ADDENDUM 1

**MAIN STREET PHASE 2a PROJECT
FEDERAL AID NO. STPUS - 8030(005)**

ADDENDUM NO. 1
To the Contract Provisions for
City of Ferndale, Washington

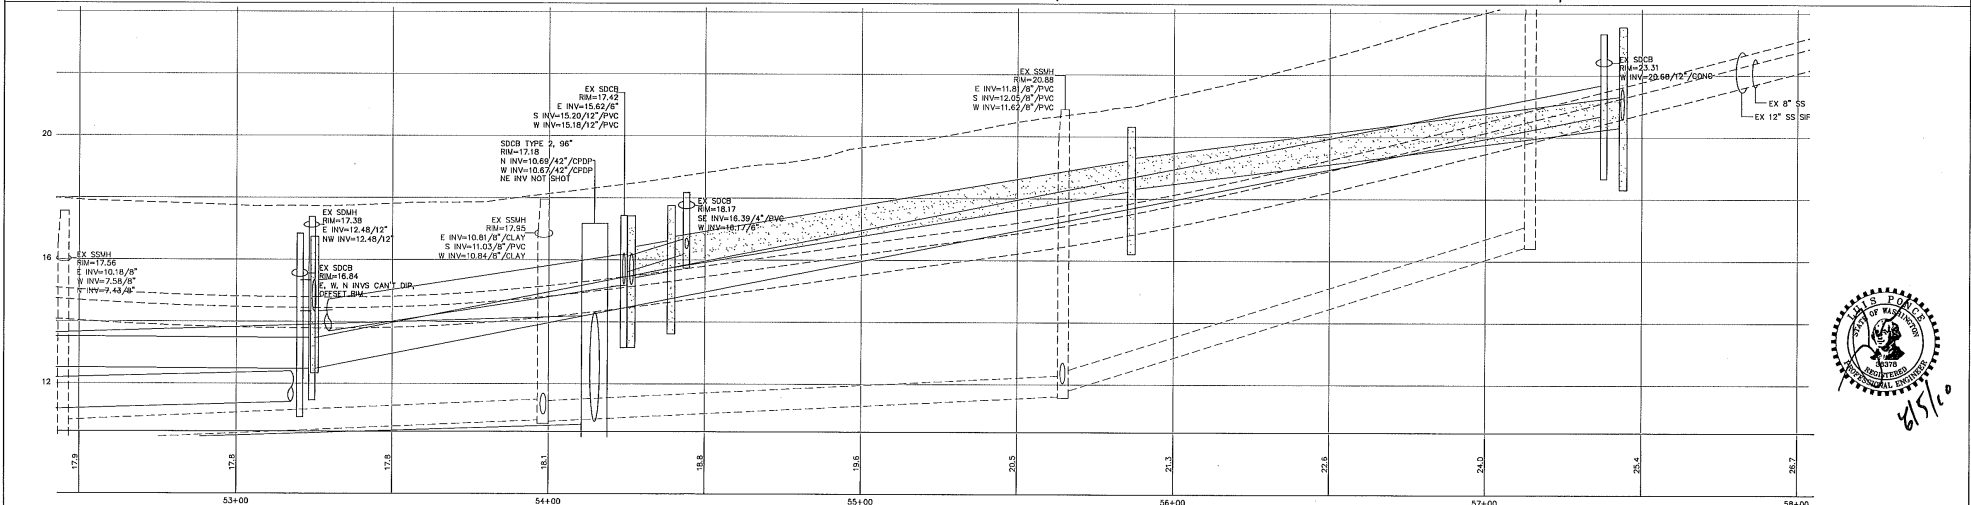
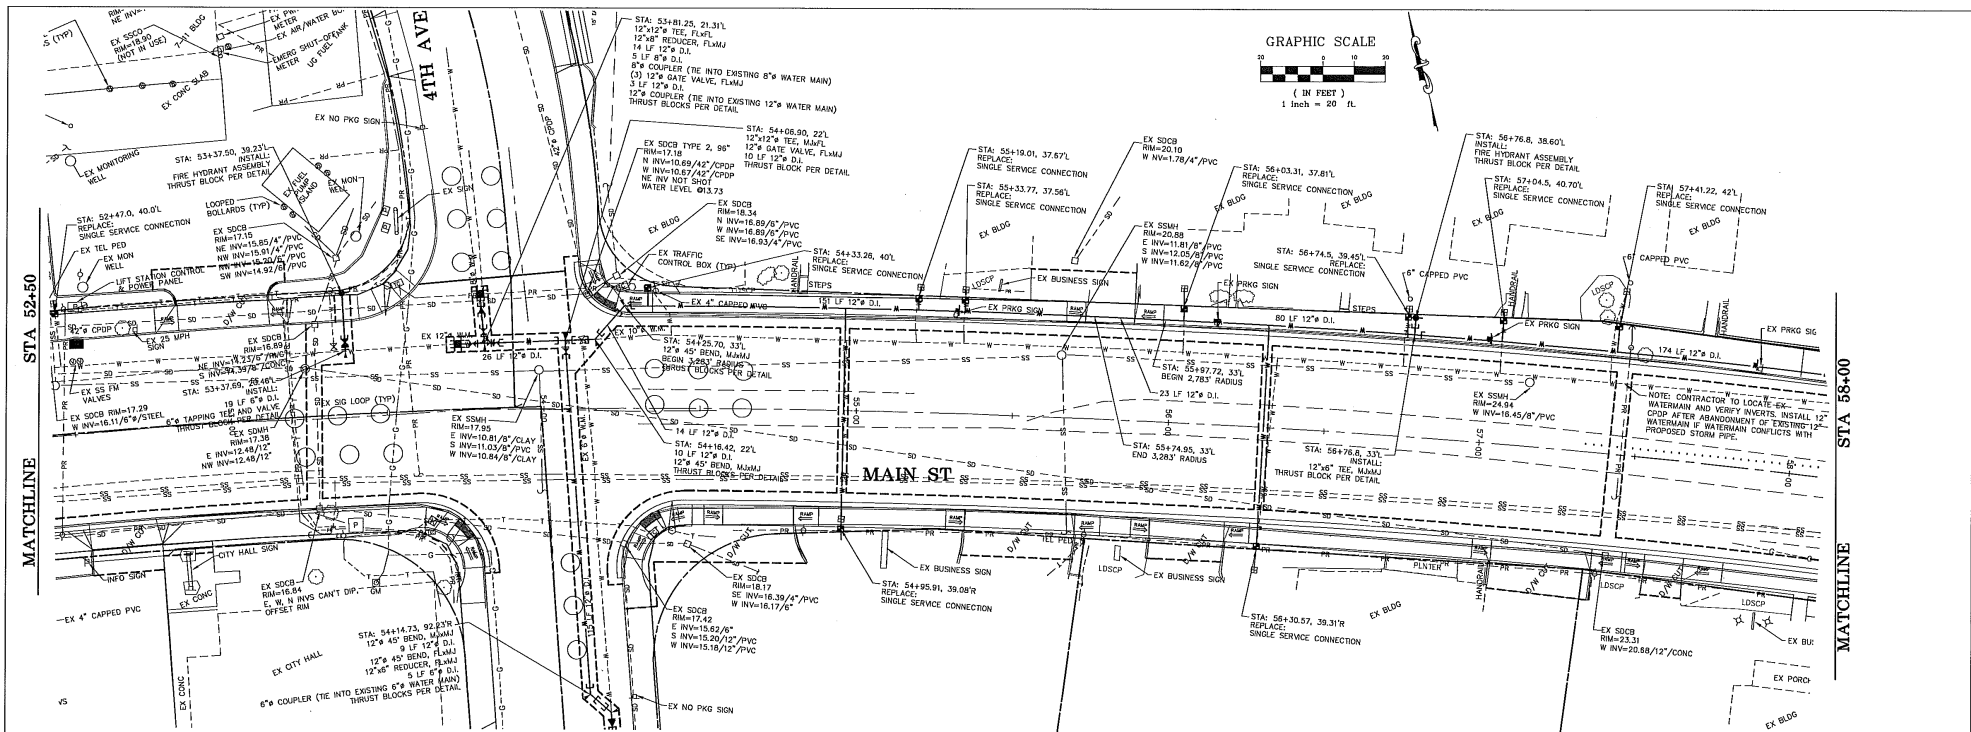
The attached Plan Sheet 13 shall replace the Plan Sheet 13 dated 7-21-10. Watermain is relocated.

JOB# / DWG	DATE
08018 08018_SP1	7-21-10
SCALE	SHEET
H:1"=20' V:1"=2'	14

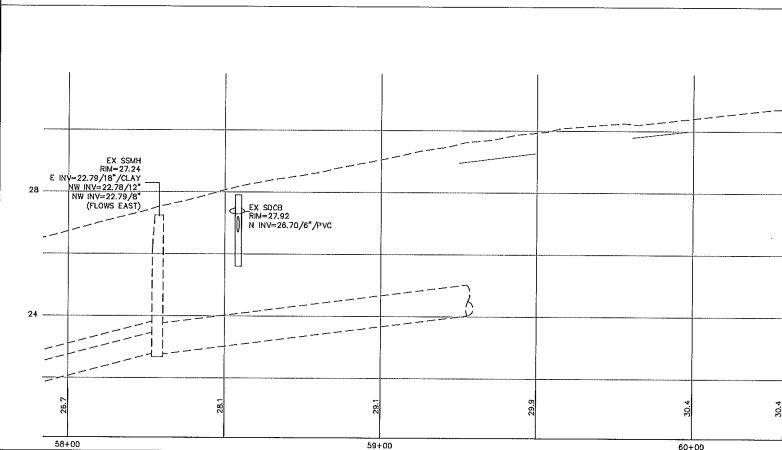
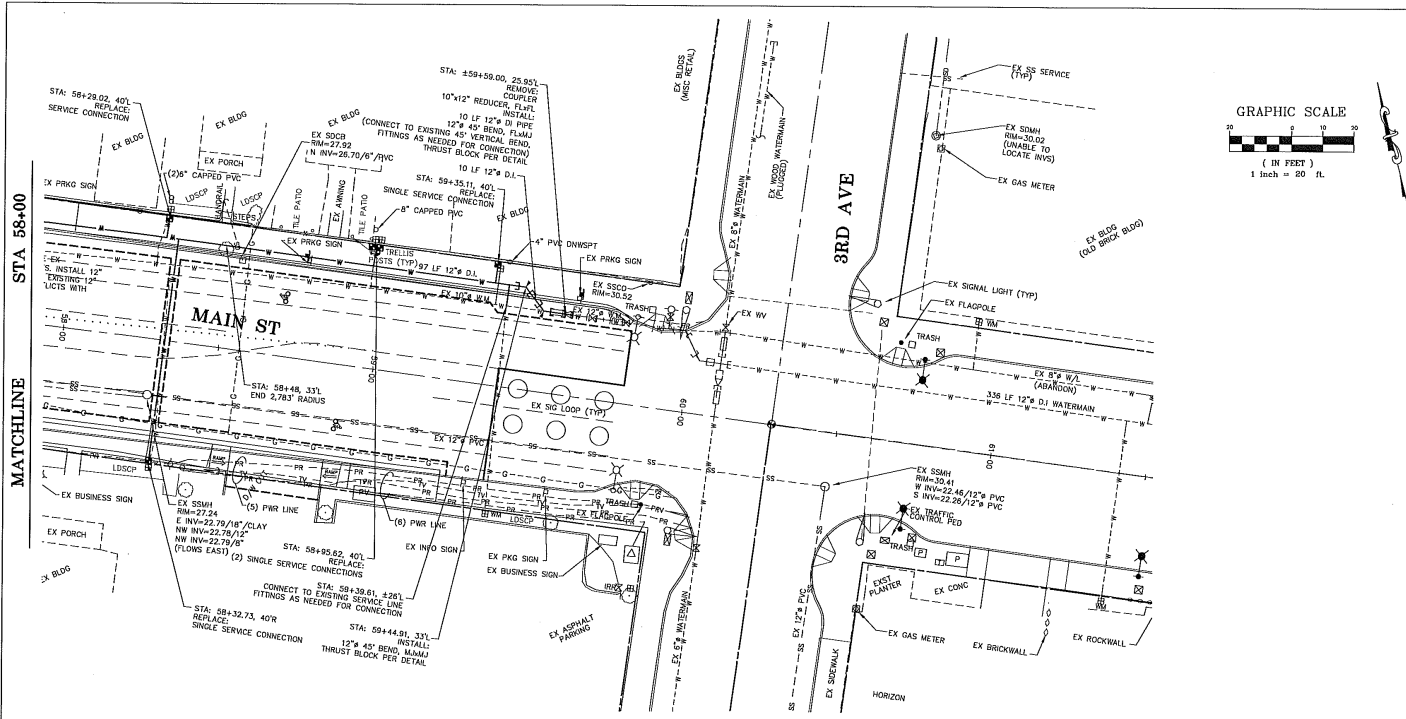
The attached Plan Sheet 14 shall replace the Plan Sheet 14 dated 7-21-10. Watermain is relocated.

MAIN STREET
ADDENDUM 1
WALL SECTIONS, ALT A1

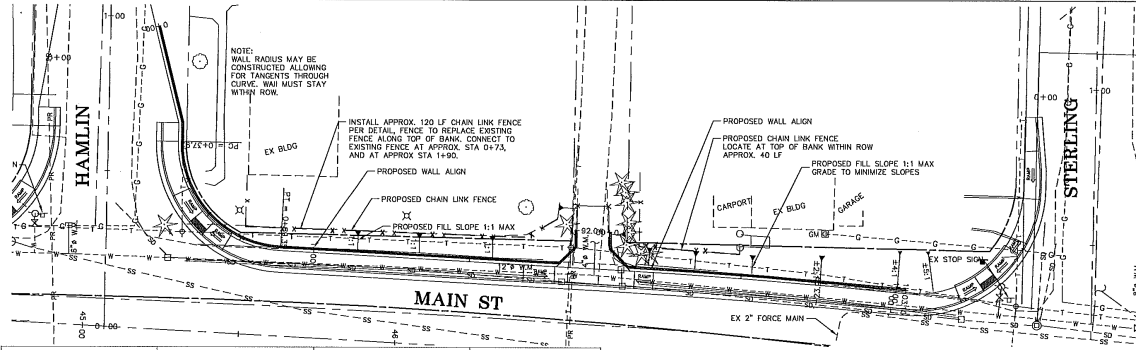
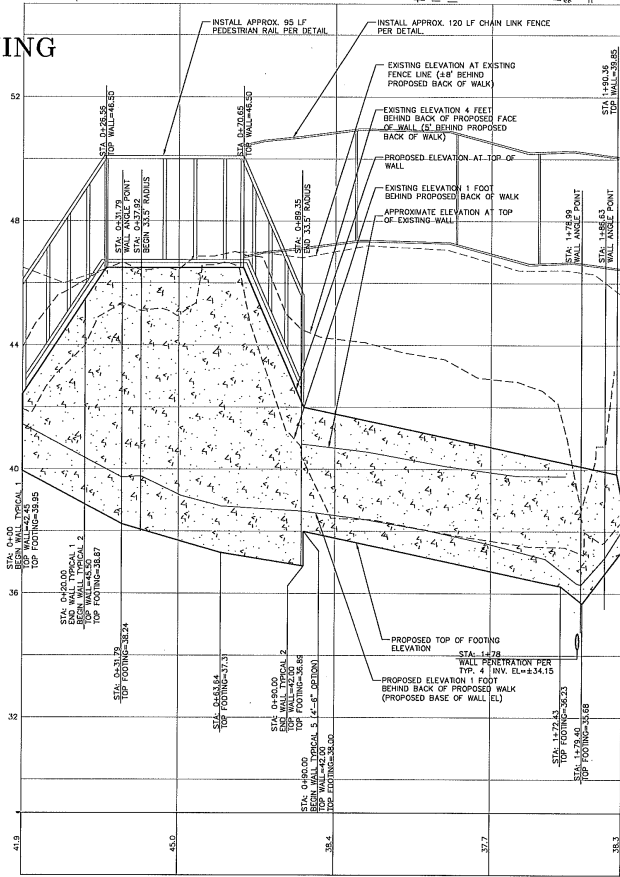
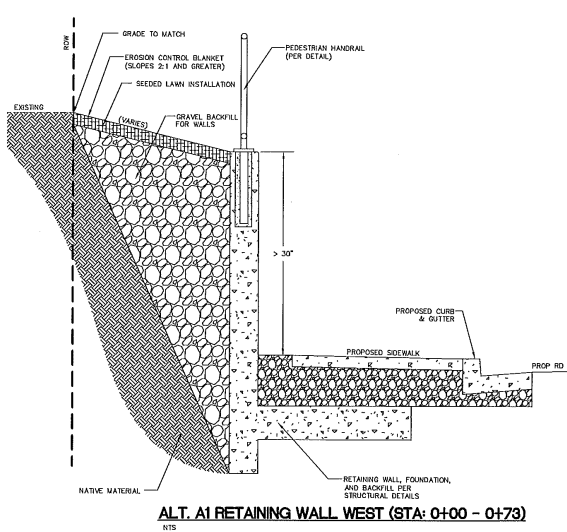
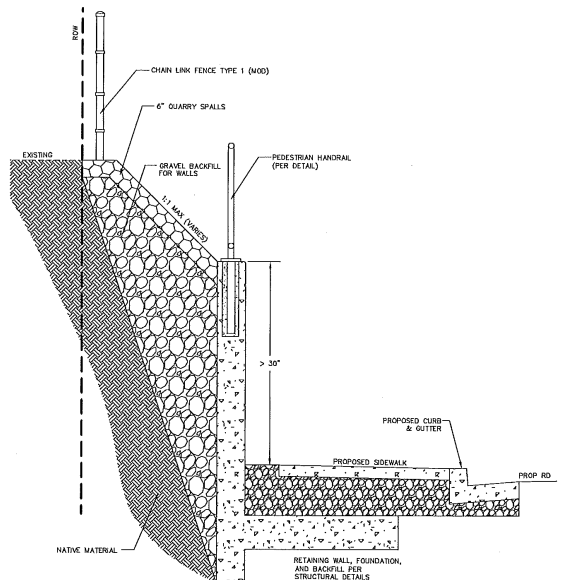
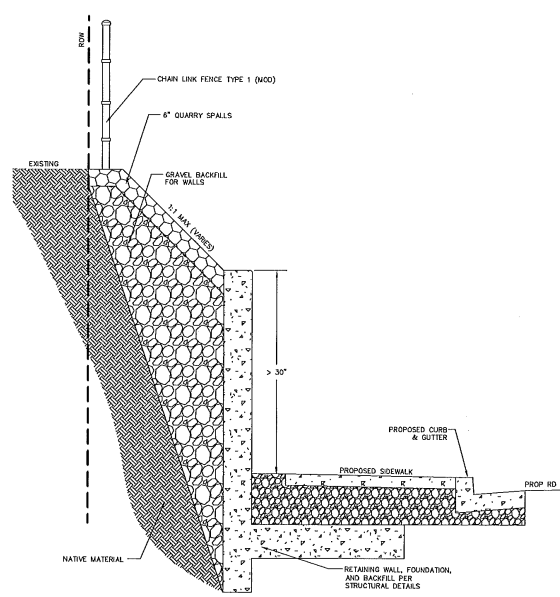
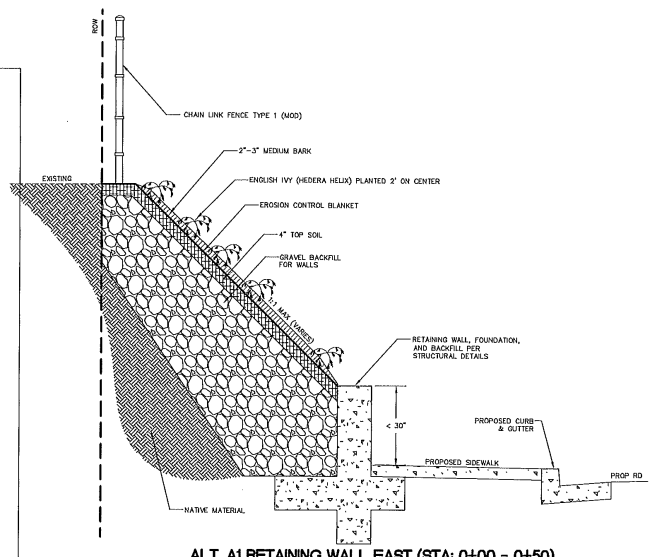
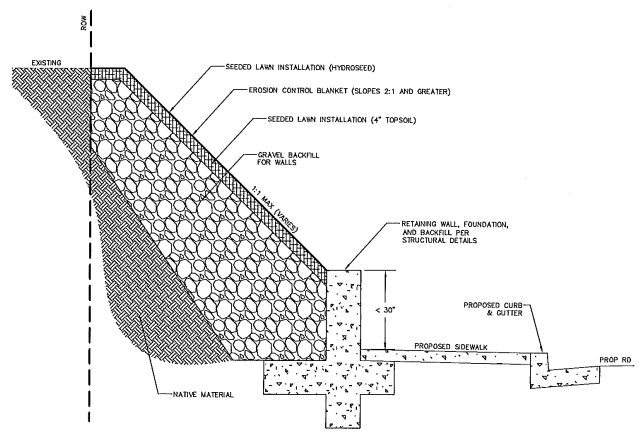
The attached Plan Sheet 16 shall replace the Plan Sheet 16 dated 7-21-10. Typical sections are revised.

JOB# / DWG	08018	08018_SP1	DWG	7-21-10
SCALE	H:1"=20' V:n/a		SHEET	23

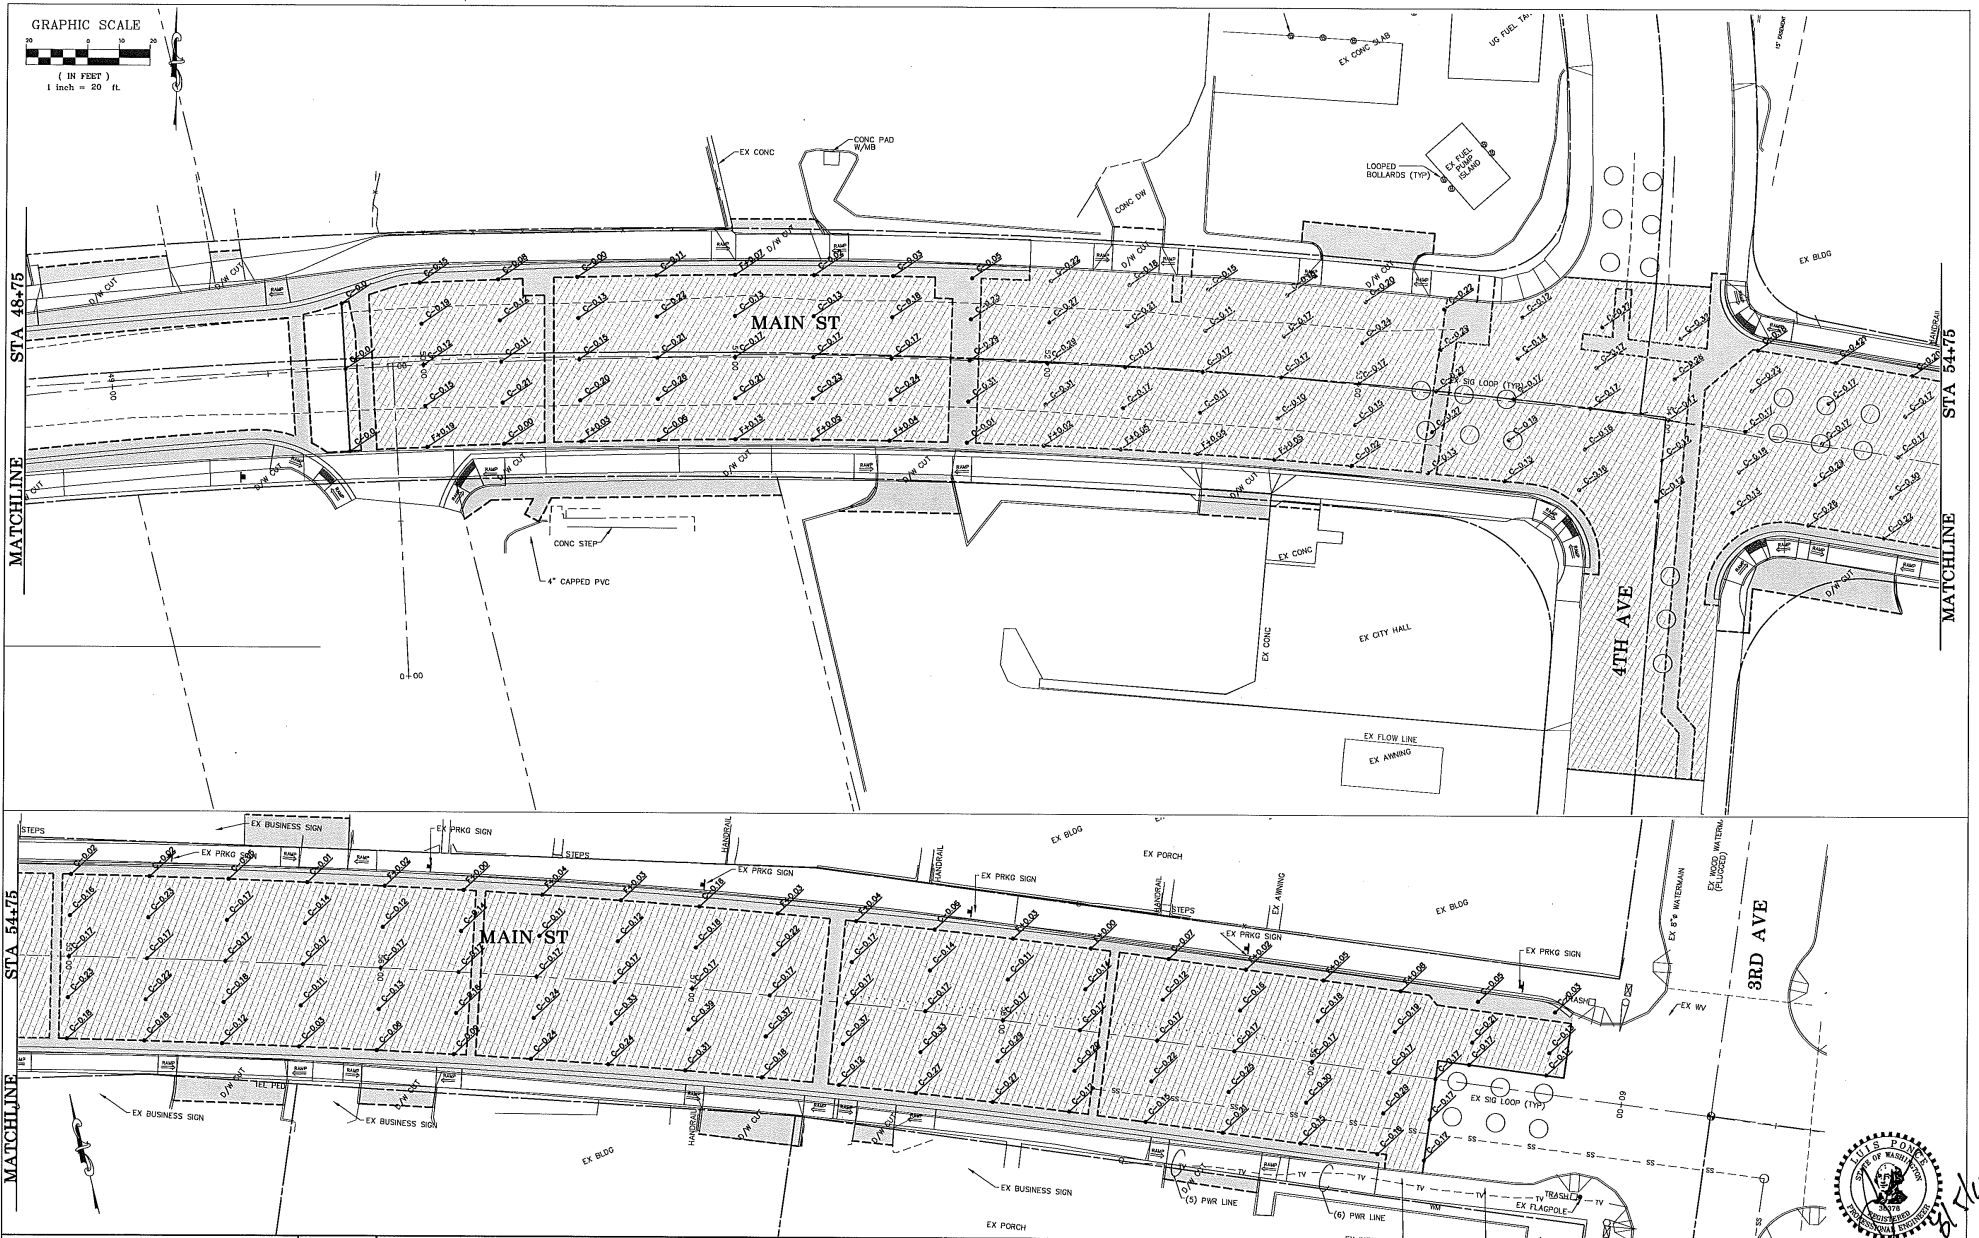
The attached Plan Sheet 23 shall replace the Plan Sheet 23 dated 7-21-10. Grades added due to relocated watermain.
